Service Letter

Service Bulletin No. SL TMG 000-1003, Revision 2
Date: January 29, 2018

Subject: Correct Installation of V-Belt

Figure 1 affected area

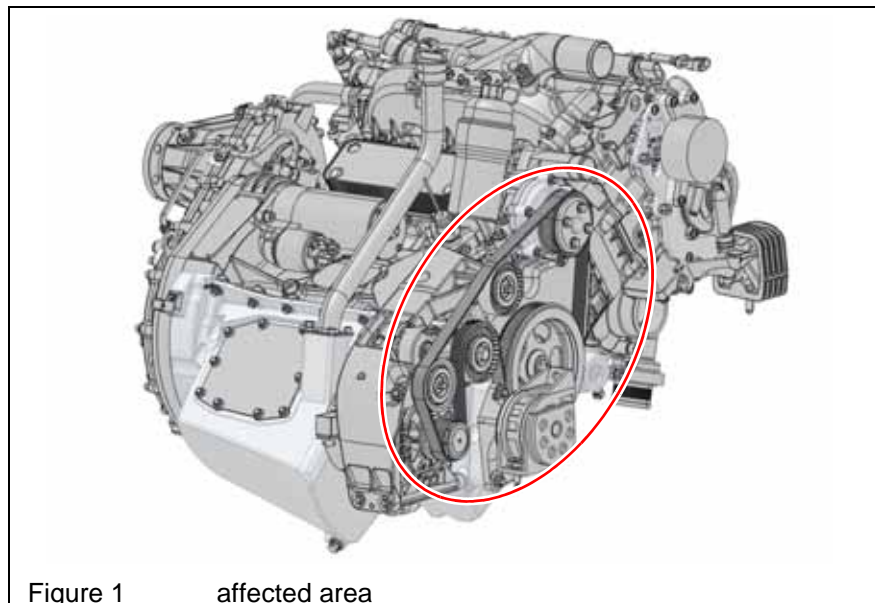
Reason: We have detected maintenance problems due to

- incorrect mounted v-belts
- v-belts contaminated by oil
- grindings by other parts

Risk of broken v-belt after incorrect installation or oil contamination. This can lead to engine overheat and engine damage, due to a failure of the v-belt driven coolant pump. This can finally lead to a power loss / IFSD.

Correction: An incorrect installed v-belt or v-belt contaminated by oil must be exchanged!
Exchange the v-belt in accordance with RM-02-01 Chapter 07.0 / RM-02-02 Chapter 72-20.01.

Figure 7

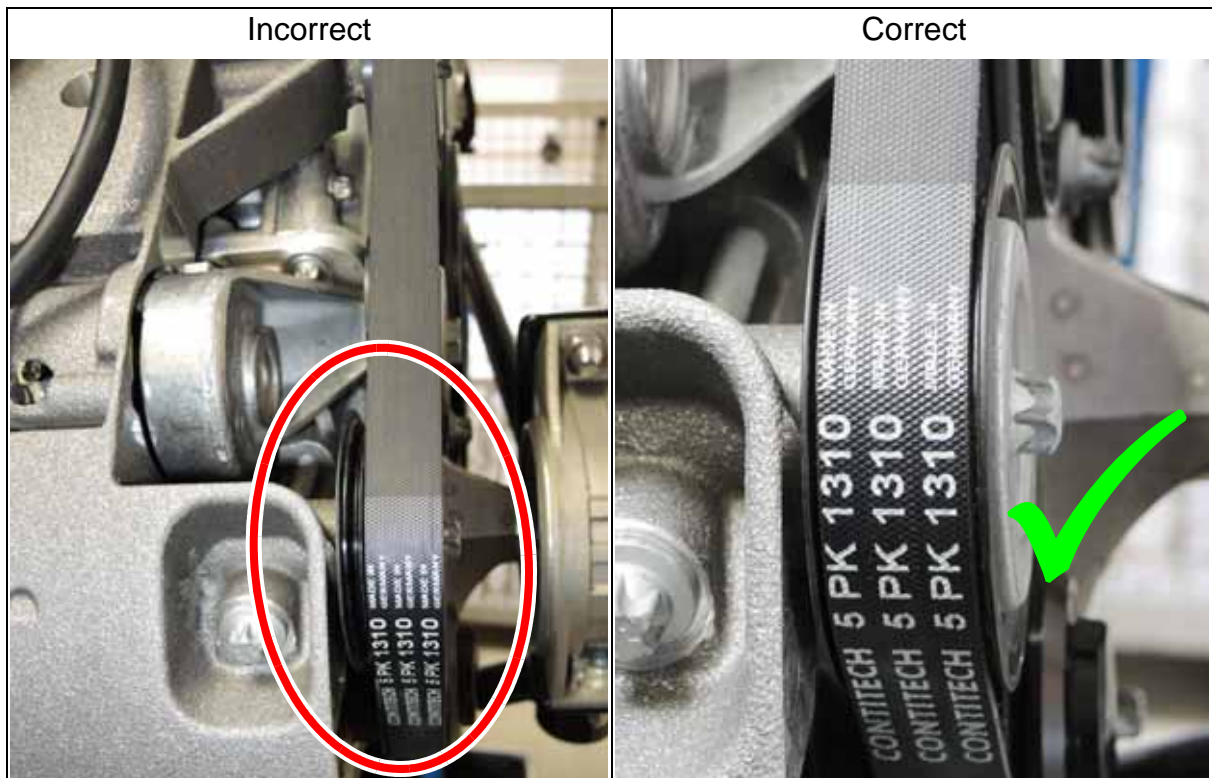
Figure 8 grindings by other parts,
Check the correct mounting of other components
Figure shows Diamond DA40
